SEQUOYAH UNIT 1 STEAM GENERATOR REPLACEMENT

RIGGING AND HEAVY LOAD HANDLING TOPICAL REPORT

PROJECT Sequoyah DISCIPLINE N
 CONTRACT 99N5B-253631 UNIT 1
 DESC. Topical Report - RSG Rigging and Handling
 DWG/DOC NO. 24370-TR-C-002-A
 SHEET - OF - REV. 03
 DATE 04/29/03 ECN/DCN - FILE N2N-059

**NRC Acceptance Letter and Safety Evaluation Report
for Topical Report 24370-TR-C-002,
“Rigging and Heavy Load Handling”**

Figure 5-2 – Outside Lift System Location

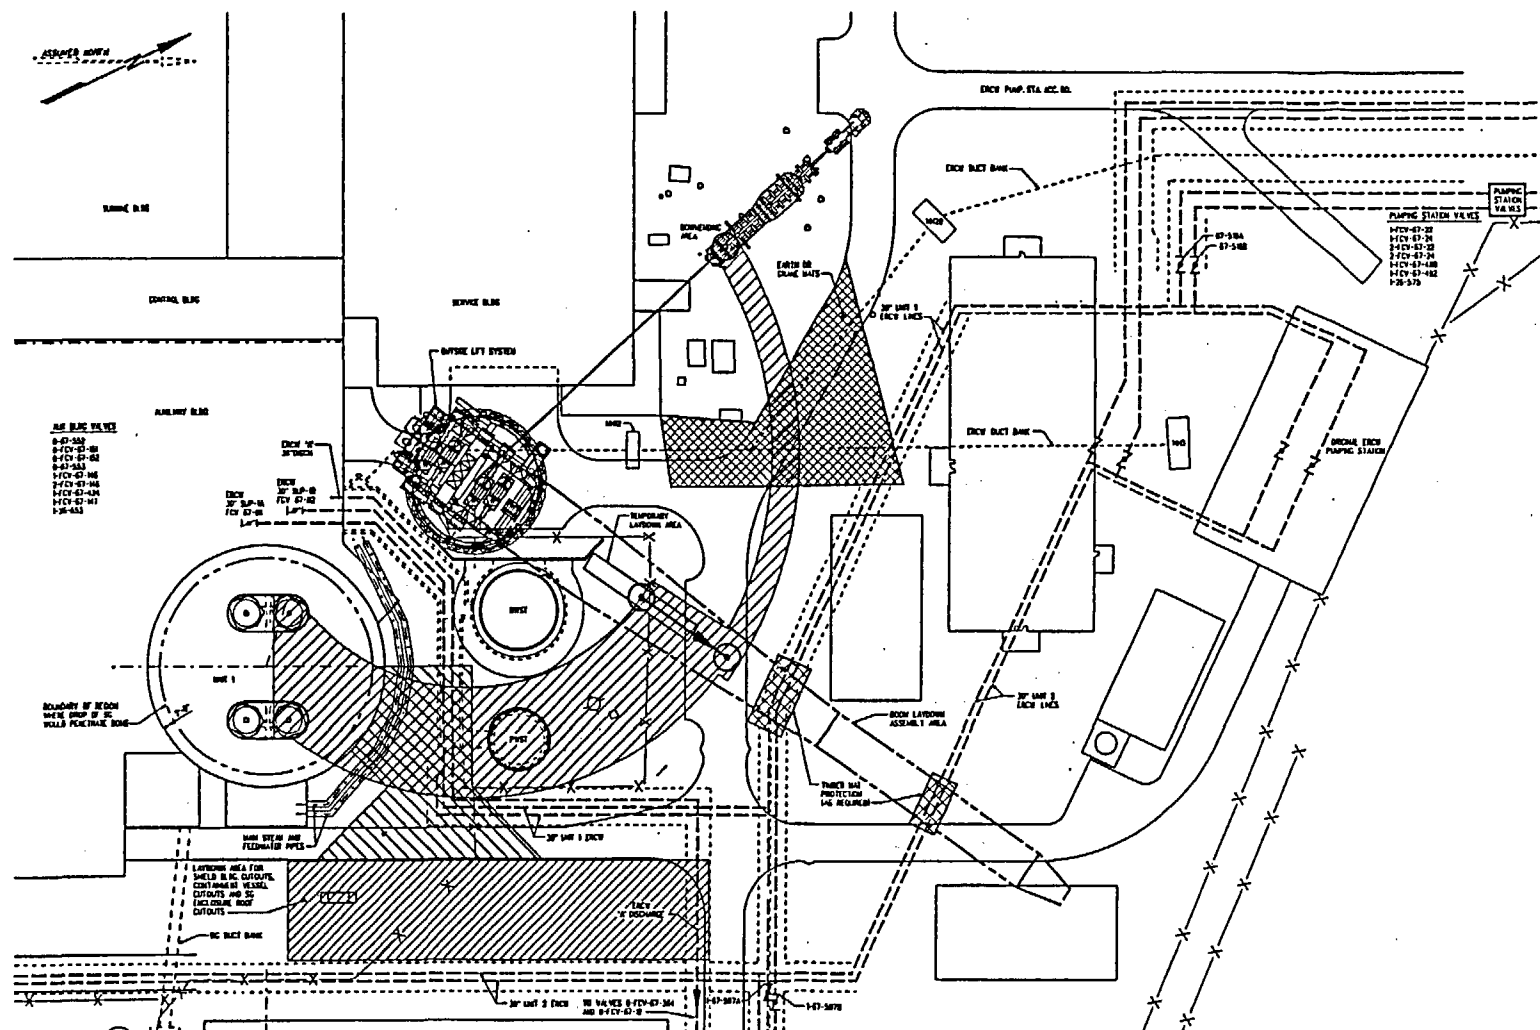
20. The topical report provides no information on the haul route from the transport location identified on Figure 5-2 and whether the potential to interact with safety-related SSCs exists along the haul route, and whether those SSCs could either withstand the impact of a dropped SG or will be protected to preclude them from damage. What is the distance between the lay down area and the old and new SG storage area and what is the method used to load test the haul route (civil/structural)? What are the safety-related components that are located along the haul route that could be impacted by a dropped SG? What safety functions/systems would be impacted? What measures are to be taken to preclude a SG drop along the haul route and preclude the identified components from being damaged if a SG drop occurred?

26. Although safe load paths have been identified on Figure 5-2 of the rigging and heavy load handling topical report the staff believes that it will be difficult for the operator to stay within the safe load path during the various lifts. Describe the communications plan, administrative controls, crane operator actions, and crane automatic actions used to control the lift within the safe load path identified in figure 5-2 of the topical report.

The approved area around the OLS boom location shown on Figure 5-2 of Topical Report 24370-TR-C-002 is a safe load path as long as the cranes are operated in accordance with the restrictions listed in 17.(a) and 17.(b) above and the protection listed in 17.(f) below is in place.

Protection (see Sections 7.5 and Figure 5-2 of Topical Report 24370-TR-C-002) for safety-related SSCs has been designed and will be used. With this protection in place, safety-related SSCs will not be affected by a load drop from or overturning of a mobile crane.

The ERCW ductbanks that are the subject of this question are: (1) Ductbank between manhole MH12 and handhole HH3 (called ductbank DB1); and (2) Ductbank between manhole MH12 and handhole HH29 (called ductbank DB2). See Figure 5-2 of Topical Report 24370-TR-C-002 for location of the ductbanks. They are both well over 200 ft in length. The critical postulated impact was from a flop-over fall after the SG has been dropped from the OLS, the load being carried at a height of 3 ft above grade along the load path at or near the ductbank locations. From TVA drawing 10N251, the grade above the ductbanks in the fall zone of a dropped generator varies from 704 ft to 707 ft. Based on the subsurface investigation performed for the SGR, the soil around the ductbanks is clay fill. The soil properties used in the evaluation were based on the above subsurface investigation and from the UFSAR.

This will require areas above the ductbank, within the fall zone, with grade elevation below 707 ft to be raised to 707 ft using any earthfill placed in a standard way. The areas where fill may be required are shown as the cross-hatched area on Figure 5-2 of Topical Report 24370-TR-C-002. The depth of fill required will vary from 0 ft to 2.5 ft. Since this is a protection for impact loading and a reasonable moment margin being available, there are no specific compaction requirements, because the energy will be dissipated by displacing the soil even if it is not well compacted. If well compacted, the energy will be further attenuated through the additional soil depth. Timber mats, having good energy absorbing properties, may also be used in lieu of earthfill. Provision of earthfill and/or timber mats as indicated above assures that the ERCW ductbanks will
